97-1, *Publication Date: JANUARY 2, 1997*

<ul style="list-style-type: none"><li>• Service Manual - Powertrain Control/Emissions Diagnosis (PC/ED) On-Board Diagnosis II (OBD II) - Cover Page Replacement To Include 1997 Vehicles With FD1060 Or FD1460 Engine</li><li>• Service Manual - Powertrain Control/Emissions Diagnosis (PC/ED) On-Board Diagnosis II (OBD II) - Cover Page Replacement To Include 1997 Windstar</li></ul>	<b>Article No. 97-1-15</b>
--------------------------------------------------------------------------------------------------------------------------------------------------------------------------------------------------------------------------------------------------------------------------------------------------------------------------------------------------------------------------------------------	--------------------------------

Article No.  
97-1-17

**Figure 3 - Article 97-12-15**

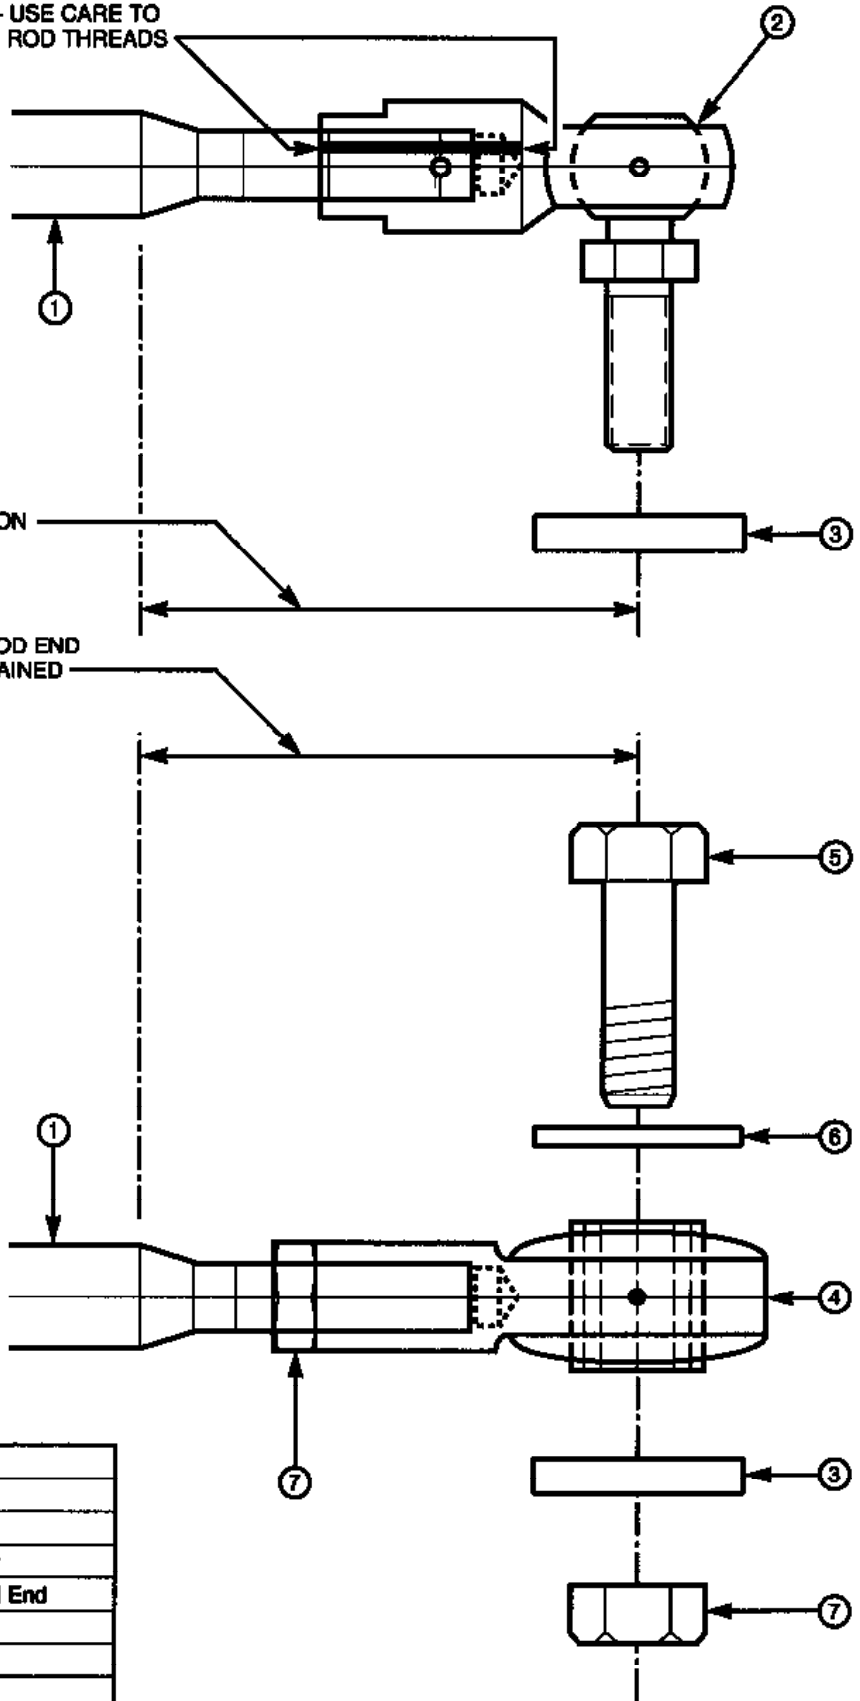
Replace the original clutch rod end with the new elastomeric rod end. The new rod end has an internal rubber isolator which may reduce the amount of vibrations that can be transmitted through the clutch rod. Refer to the following Service Procedure for details.

3. Measure the distance from the center of the ball stud to the collar of the clutch rod as shown in Figure 3. Note this measurement.
4. In addition, mark the clutch rod to note the orientation of the ball stud in relation to the clutch rod.

**Figure 3 - Article 97-19-21**

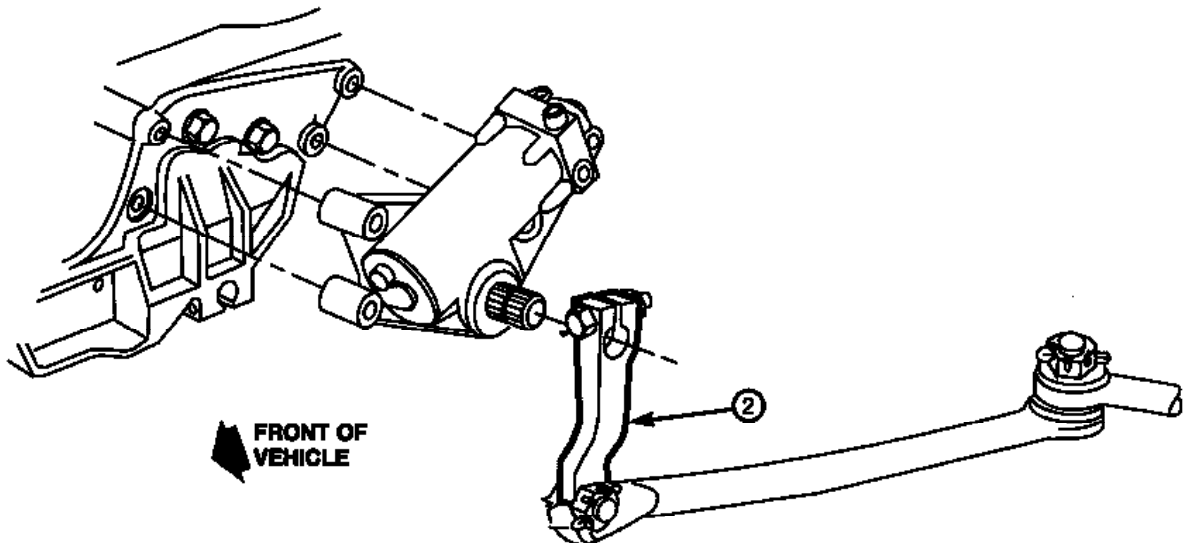
5. Replace the two (2) existing pitman arms with revised Pitman Arms (F8HZ-3590-CA - Right Side, and F8HZ-3590-DA - Left Side) (Figure 3).
6. Check the front end caster and toe-in, and if necessary adjust to specifications listed in the appropriate Louisville/AeroMax Service Manual, Section 04-00.

**Figure 2 - Article 97-21-17**

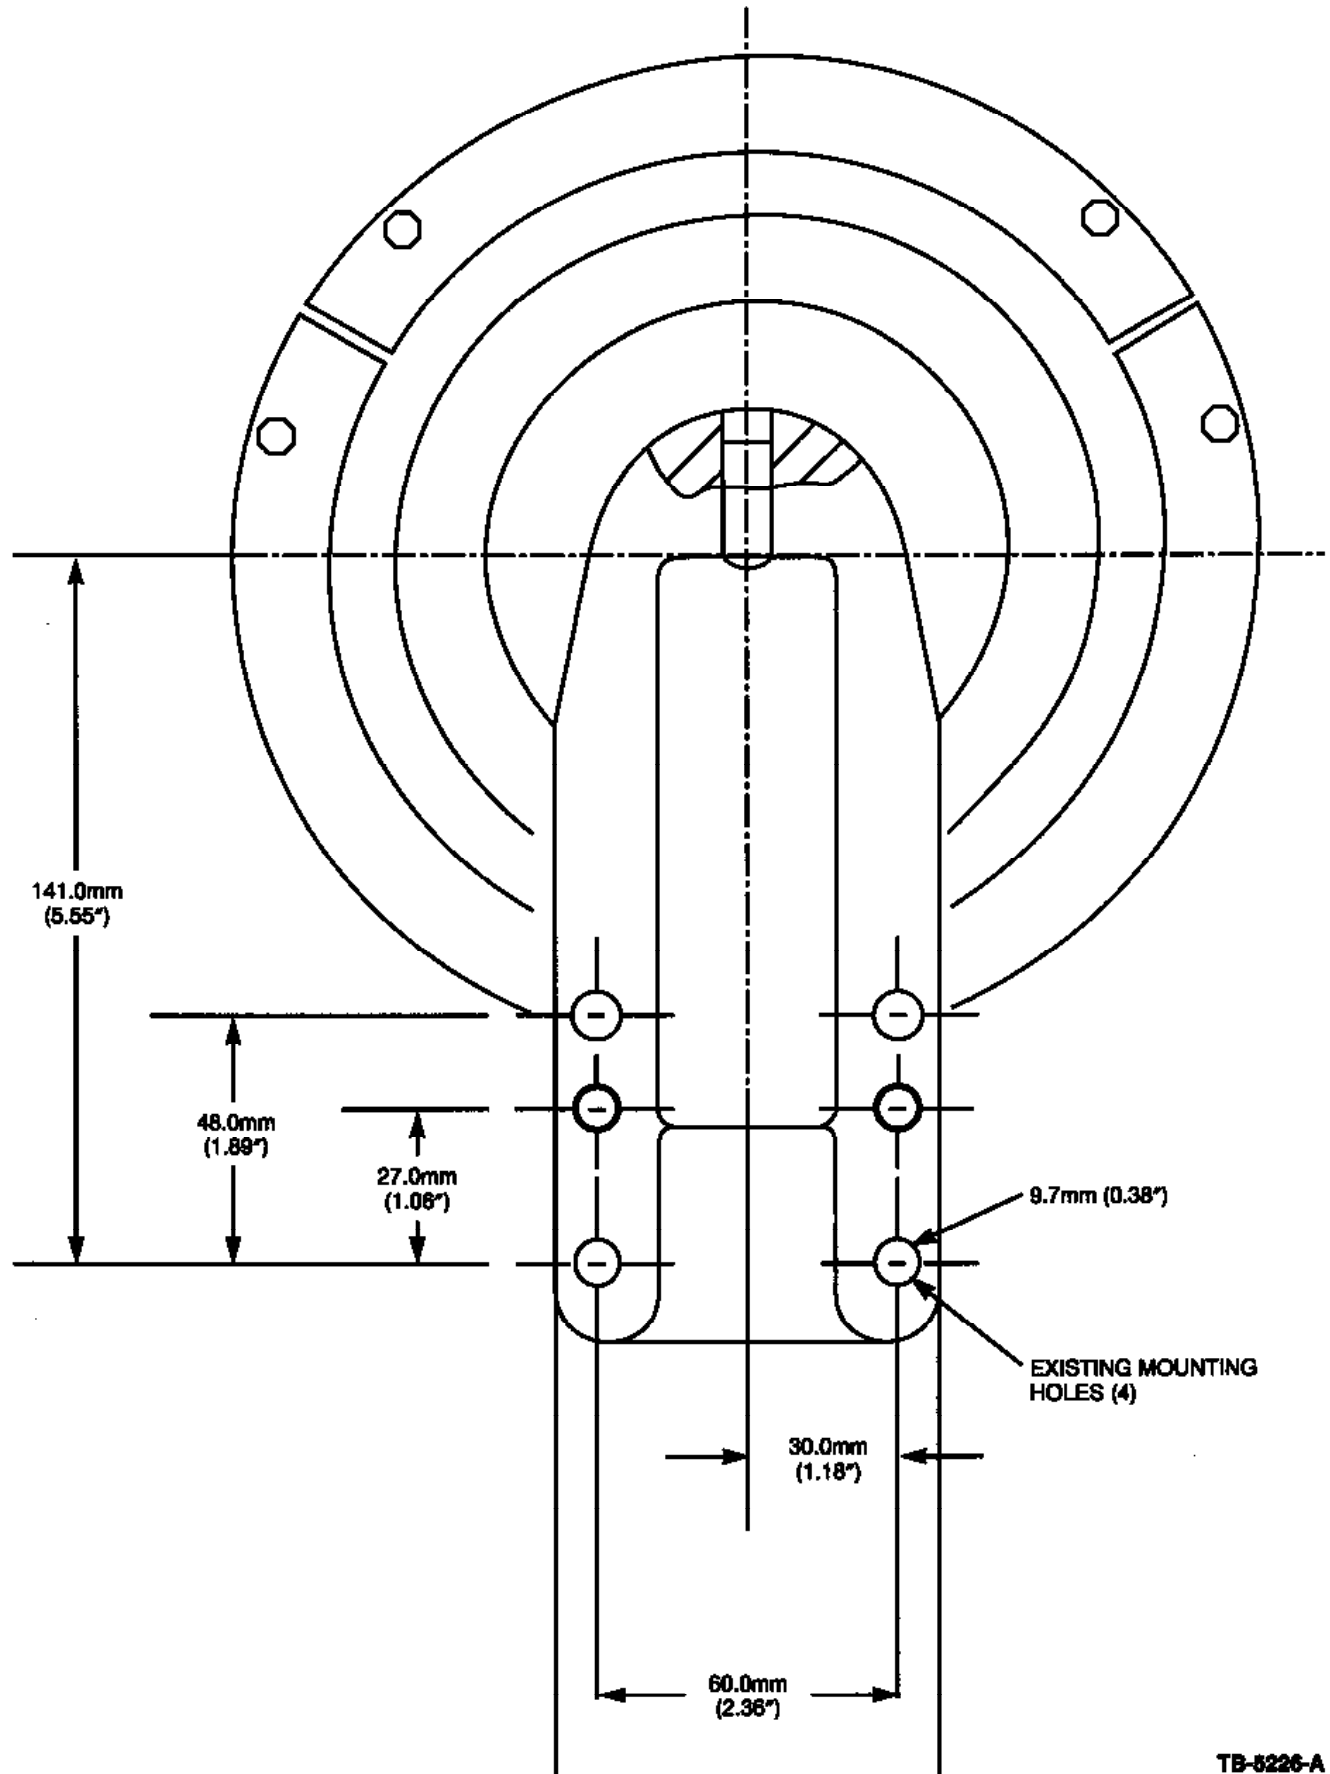
The fan clutch attaching bolts may become loose on some vehicles equipped with the Kysor on/off fan clutch. This may be due to the original fan mounting hub not being robust enough.

7. Carefully mark the new attaching bolt locations on the mounting flange using the information provided in Figure 2.
8. Drill two (2) 9.7mm (0.38") holes at the locations marked.
9. Reinstall the fan hub/clutch assembly onto the engine using six (6) new Bolts (N601212-S2) and six (6) new Washers (N630068-S2). Be sure to coat the bolts with Ford Threadlock 262 (E2FZ-19554-B) prior to installation.
10. Torque the six (6) bolts to 22-33 N-m (16-24 lb-ft).
11. Install the fan hub/clutch air line.
12. Install the serpentine drive belt.
13. Install the fan assembly and torque the bolts to 42-57 N-m (31-42 lb-ft).
14. Install the air charge cooler tube and torque the clamps to 2-3 N-m (18-27 lb-in).
